Comment : Figure 145-15 pages 144 and 145.

This comment is about Primary Alternative dual-signature semi-independent PSE state diagram and the proposal discussed over mails for the need to allow LCE after class probe as we did for SSPD.

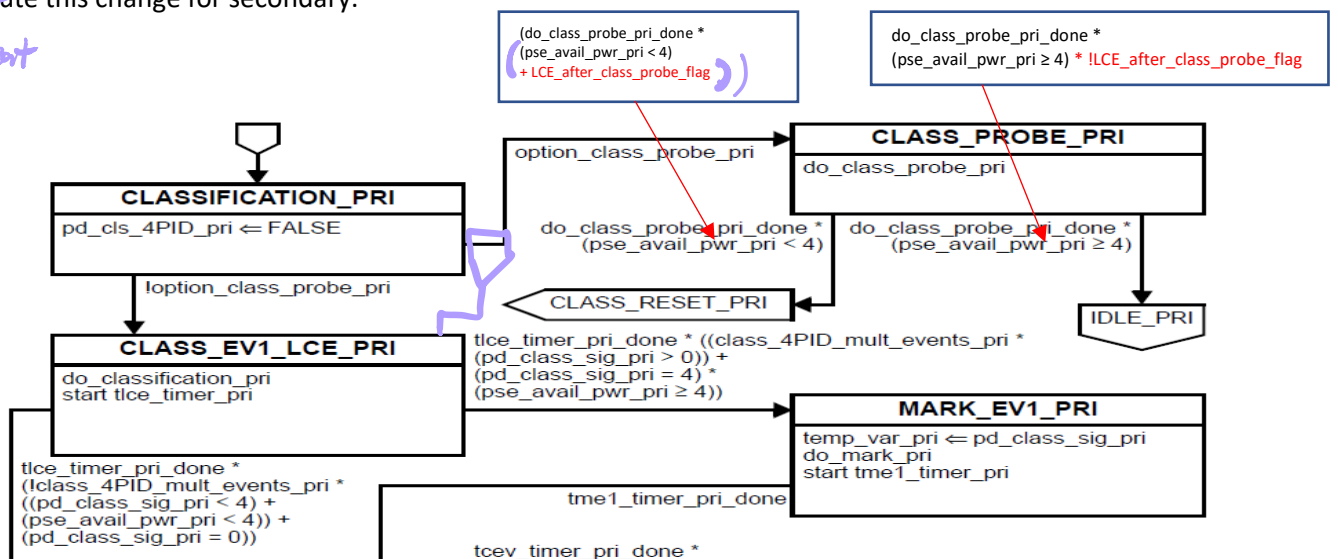
The following proposal is almost similar to Chad's proposal with the following difference:

It allows to keep the current state machine but if user which to allow the above objective, he needs to set a variable to be true to set this option.

Proposed Remedy for page 144

1. Add variable and make the following changes in the state machine

LCE_after_class_probe_flag

An optional variable to allow CLASS_EV1_LCE_PRI after CLASS_RESET_PRI.

2. ~~Repeat~~ this change for secondary.
